**2012-2014 ICC CODE DEVELOPMENT CYCLE
UPDATES TO THE 2013 PROPOSED CHANGES
TO THE INTERNATIONAL CODES
GROUP B**

The following is a compilation of errata discovered since the posting of the monograph on March 11th, 2013.

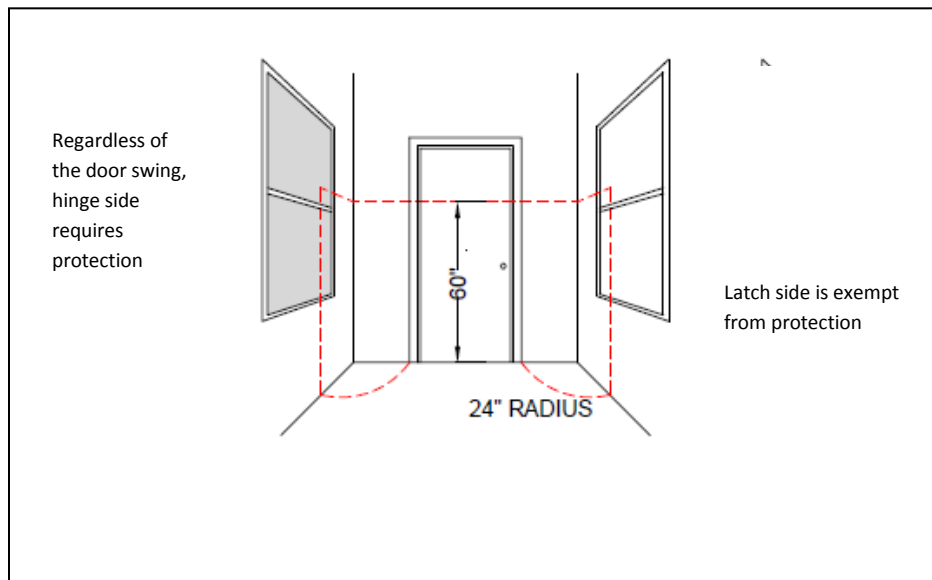
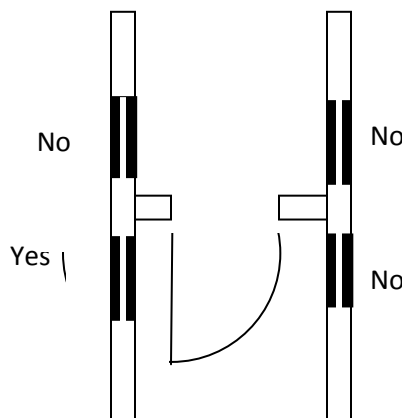
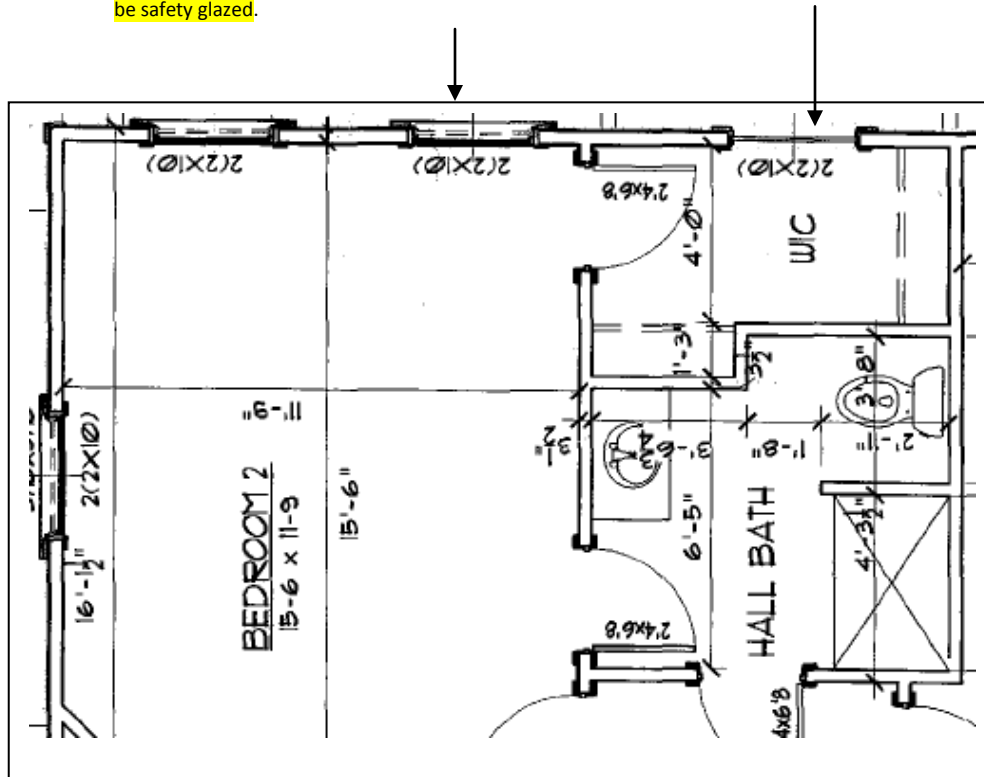
Exception 3: Currently the code requires safety glazing for windows on the hinge side of walls perpendicular to the door plane – regardless of the door swing. See sketch below.

This code change was rewritten to say that the safety glazing is only required on the hinge side of an in-swinging door where someone could get knocked out of the window if someone opens the door from the other side. There is no similar threat for the person on the outside of the door swing.

Currently this window is NOT exempt by rule # 3 (or #4) and would have to be safety glazed. If this proposal is accepted, this window would NOT have to be safety glazed.

This window is currently exempt because the arc is more the 24" from the door hinge.

These are the four possible configurations of windows adjacent/perpendicular to a door. Only the one with an in-swinging door on the hinge side would be required to be safety glazed.

Figure AH106 **Ultimate Design Wind Speeds for Patio Covers and Screen Enclosures**

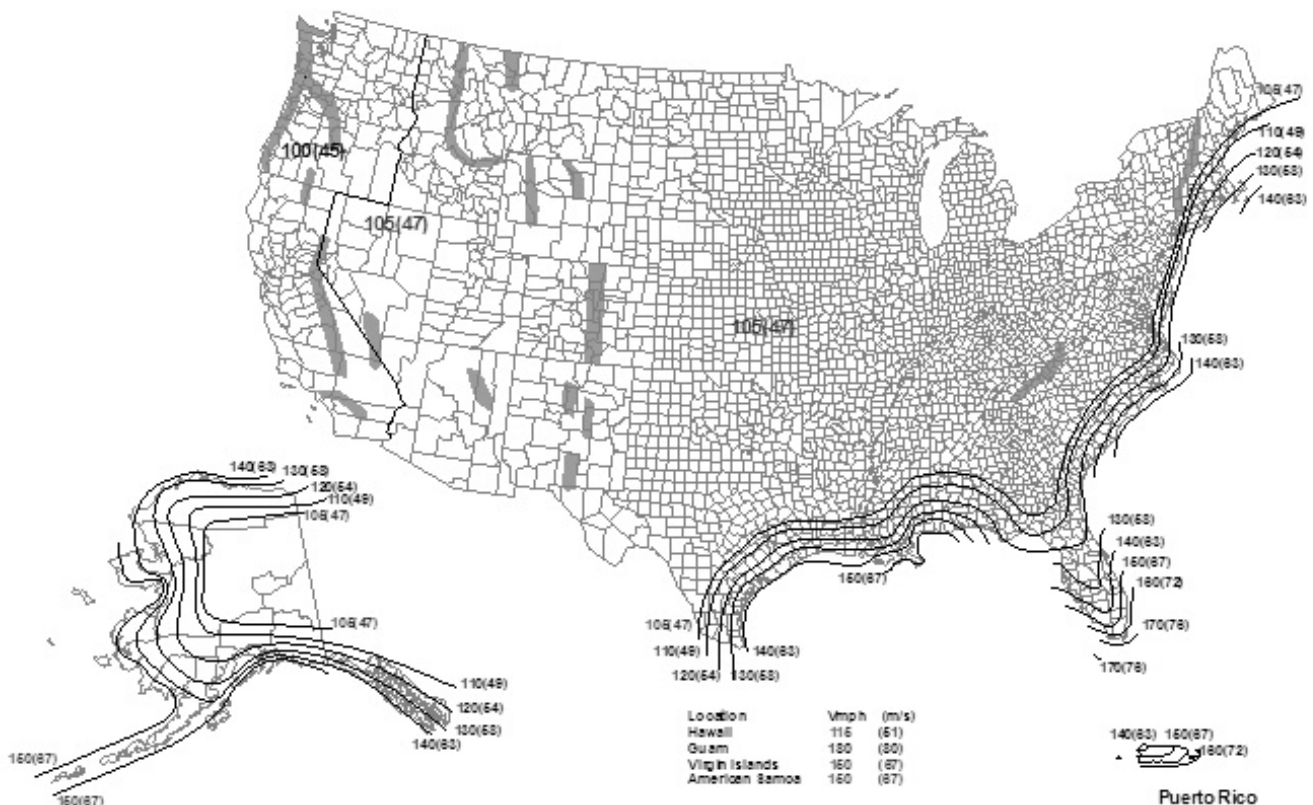
RB466-13: Figure AH106 did not show in previously published code change. No changes to remaining code change.

map for Risk Category I structures (which includes patio covers) to replace the use of the 0.87 (non-hurricane) and 0.77 (hurricane) importance factors, Section AH106.4.3 is deleted and a new Figure AH106 copies the Risk Category I wind map from IBC Figure 1609C.

FIG. X1.2 Steel Frame for Loose Fill Materials

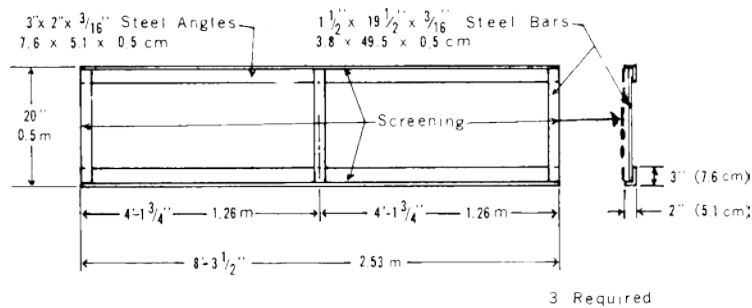
X1.6.1 Loose-fill insulation shall be placed on galvanized steel screening (Note 11) with approximate 3/64-in. (1.2-mm) openings supported on a test frame 20 in. (508 mm) wide by 2 in. (51 mm) deep, made from 2 by 3 by 3/16-in. (51 by 76 by 5-mm) steel angles (see Fig. X1.2). Three frames are required to cover the full tunnel length. The insulation shall be packed to the density specified by the manufacturer.
